Product Change Notification

Product Group: SFERNICE / May 16th 2019 / PCN-SF-233-2019 Rev 0

SFERNICE PRECISION POTENTIOMETERS Qualification of a new Silver based painting supplier

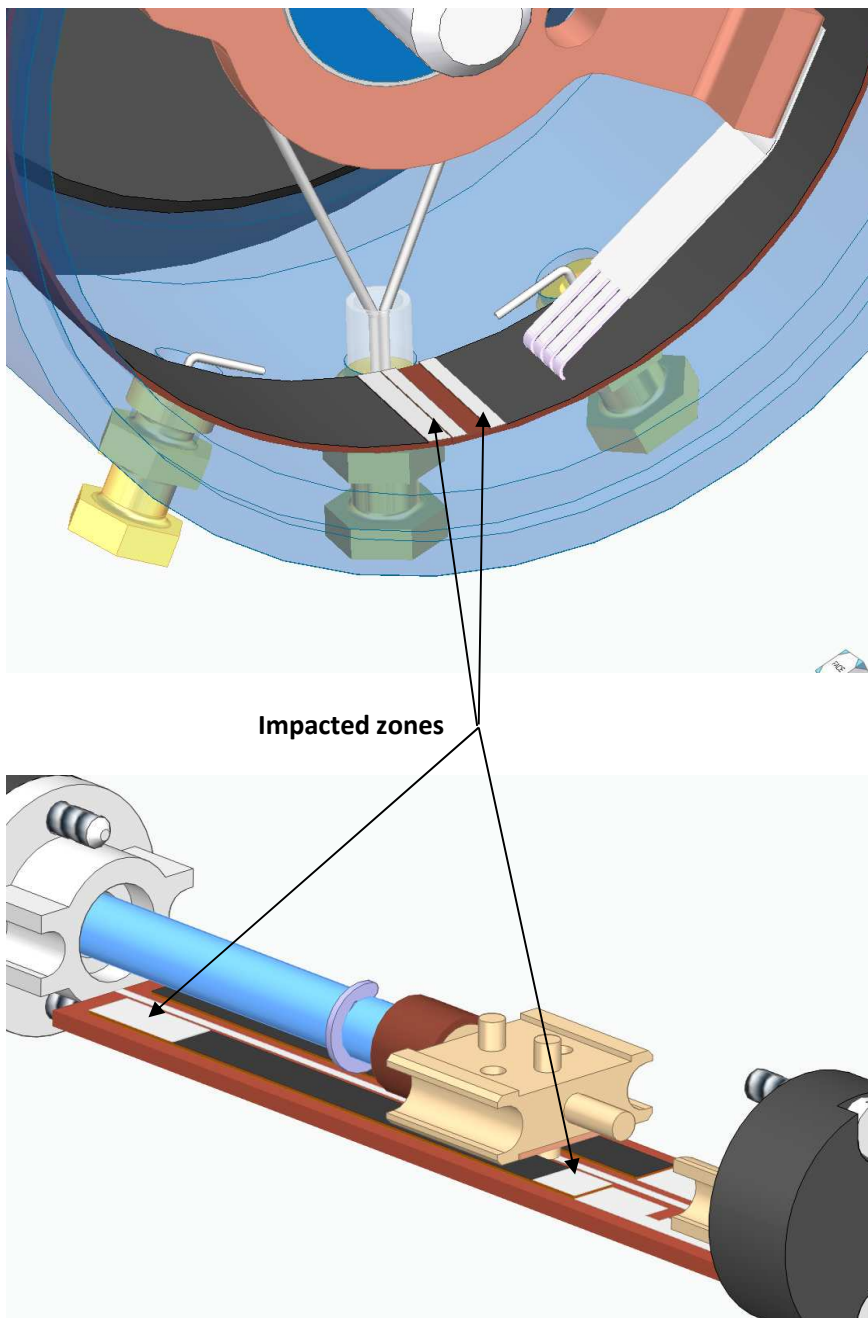
DESCRIPTION OF CHANGE: In line with our commitment for continuous improvement and procurement safety, Vishay Sfernice is adding a qualified source for the Silver based conducting painting used at the beginning and the end of the electrical travel in Precision Potentiometers (drawing examples in page 2). **All products specifications remain unchanged.**

Current material deliveries supply are becoming risky. The new conductive painting remains a Silver filled phenolic polymer resin.
